TECHNICAL SERVICE BULLETIN

10073

MODEL(S): 29 LX, 29 LX LE

DESCRIPTION: Increasing the talkback volume

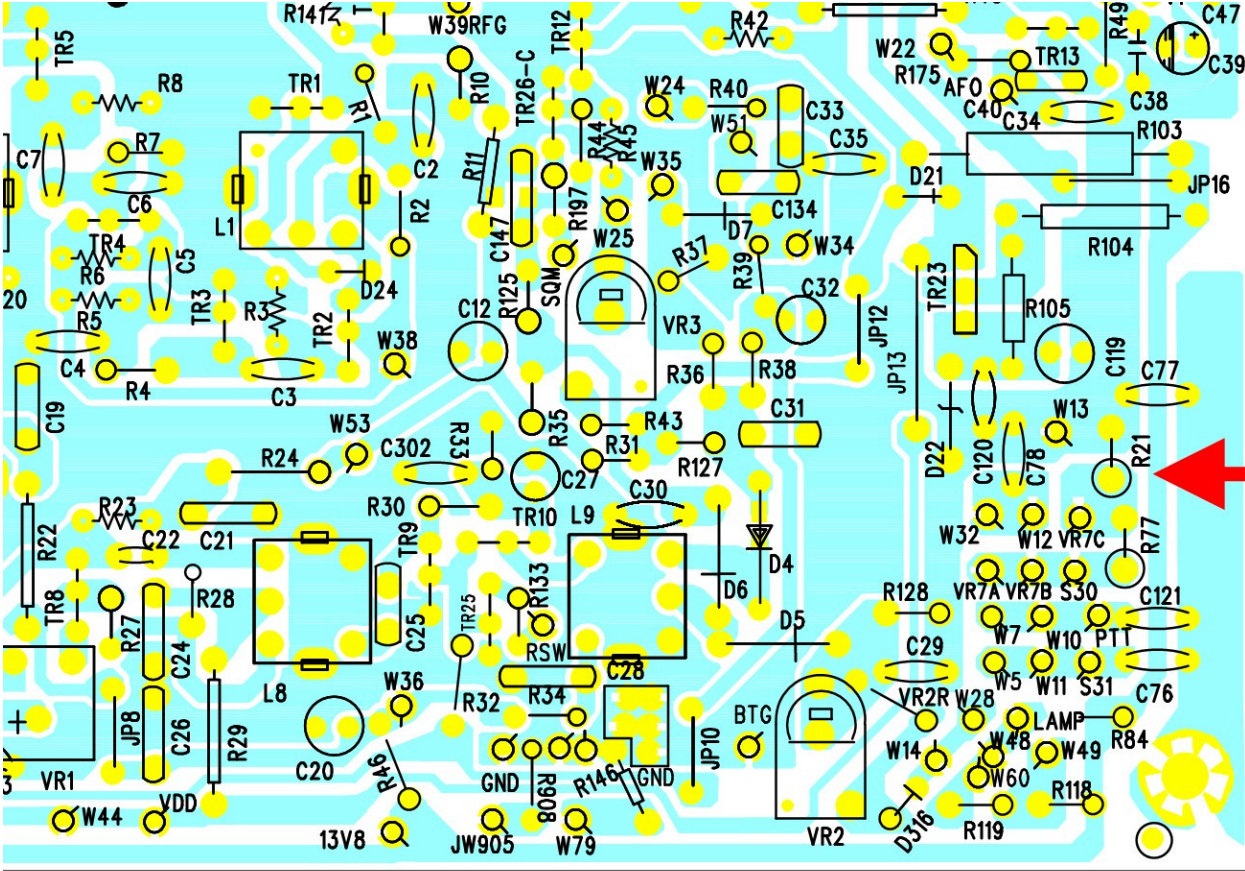
ACTION: To increase the talkback volume, reduce R21 from 91 ohms to 10 ohms. Refer to the following page for the location of R21.

NOTES: **WARNING:** This modification will increase the talkback volume, which will also increase the possibility for acoustic feedback. If the radio squeals when transmitting, then turn down the talkback volume. Depending on the microphone that is used and the location of the speaker, this modification may render the talkback feature unusable due to squealing. Note that this issue may not occur until a later date, simply by changing one or more of the following:
